REFERENCE:	TSB: 08-151-23 GROUP 08 - Electrical	Date:	June 21, 2023	REVISION:	—
VEHICLES AFFECTED:	2023 (DT) RAM 1500 Pickup 2023 (DS) RAM 1500 Pickup This bulletin applies to (DT) vehicles built on and before June 27, 2023 (MDH 0627XX) and (DS) vehicles built on and before June 05, 2023 (MDH 0605XX) equipped with Global Telematics Box Module (Sales Code RDG).			MARKET APPLICABILITY:	
CUSTOMER SYMPTOM:	Customers may experience one or more of the following: <ul style="list-style-type: none"> • Uconnect Box Message at Startup. • Uconnect Box Error Or Requires Service Message. • Connectivity: Uconnect Mobile App trunk status showing as closed when trunk is open. • Connectivity: Diagnostic Trouble Codes (DTCs) for Electronic Control Modules (ECUs) won't be shown to customer through the Vehicle Health alert (Mobile app or email). 				
CAUSE:	TBM Software

Fig. 1
Uconnect Box Error Message

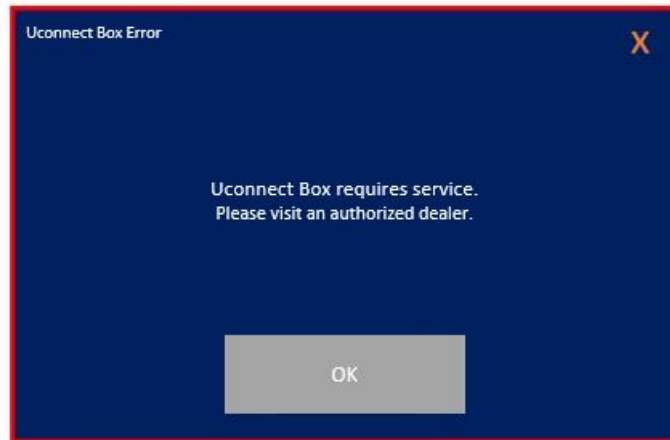
Message display on the radio screen, “Uconnect Box requires service. Please visit an authorized dealer.” (Fig. 1) , with no active or stored DTCs set by the TBM.

This bulletin provides information regarding the latest Firmware Over The Air (FOTA) update and provides the service technician an overview of the steps a customer will need to take to complete the update. The TBM software will be updated from 5.25 to 5.39.1.
